Proposal for the 02 series of amendments to UN Regulation No. 86 (Installation of lighting and light-signalling devices for agricultural vehicles)

Submitted by the Working Party on Lighting and Light-Signalling*

The text reproduced below was adopted by the Working Party on Lighting and Light-Signalling (GRE) at its eighty-fourth session (ECE/TRANS/WP.29/GRE/84, para. 30). It is based on ECE/TRANS/WP.29/GRE/2020/7/Rev.1. It is submitted to the World Forum for Harmonization of Vehicle Regulations (WP.29) and to the Administrative Committee (AC.1) for consideration at their November 2021 sessions.

Figure 1

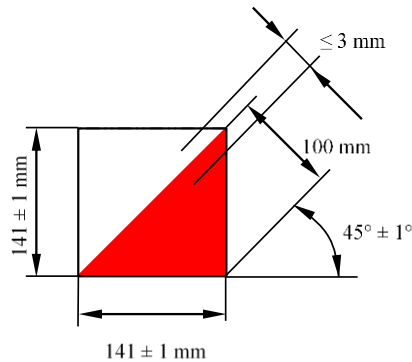
Paragraph 1.1, amend to read:

"1.1. Signalling panels and signalling foils shall have the following dimensions:"

Figure 2

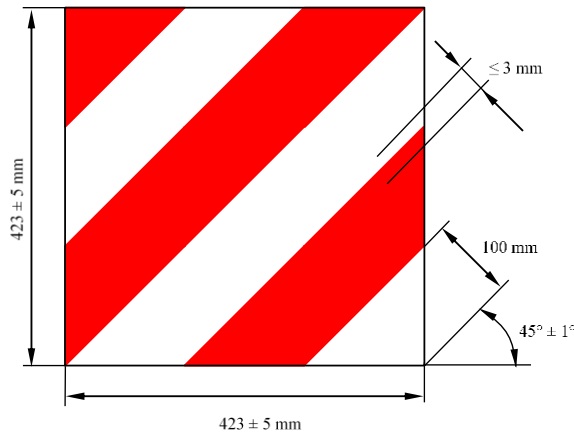
Paragraph 1.1, Table 1, amend to read:

Deviations from the specified formats are permitted, provided that:

- (a) The visible surface of each panel or foil shall be at least equal to 4 basic standard areas and
- (b) Each panel or foil shall comprise at least 3 entire basic standard areas.

If the structure, design or the operational use of the vehicle makes it impossible to comply with such a requirement, each panel or foil may be split into 2 parts as long as each part comprises at least 2 entire basic standard areas."
